Cannot open file C:\Users\Public\Documents\Altium\AD14\Templates\Emko-logo.bmp	
PROJE KODU:	DOSYA ADI:
PROJE ADI:	Microcontroller_2.SchDoc
BÖLÜM ADI: MICROCONTROLLER	TARİH: 26.01.2018
ÇİZEN:	ONAY:
REV. NO:	
SAYFA: 2 /

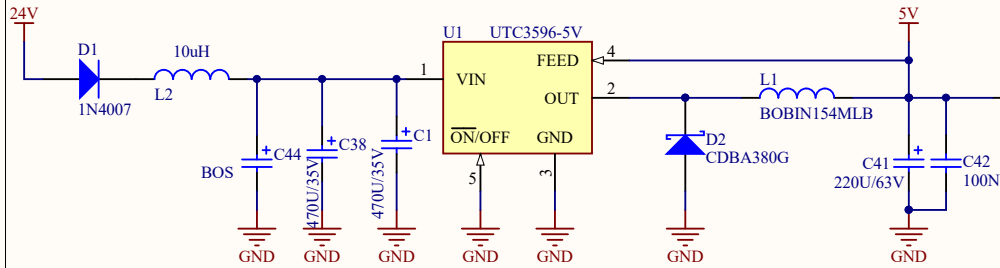
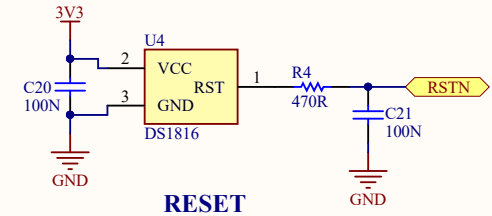
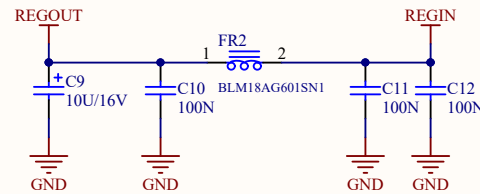
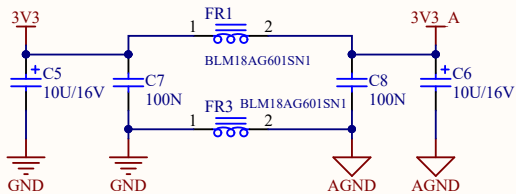
If you put 10 ohm resistor instead of FR1,FR2 there is some improvement in the problem.
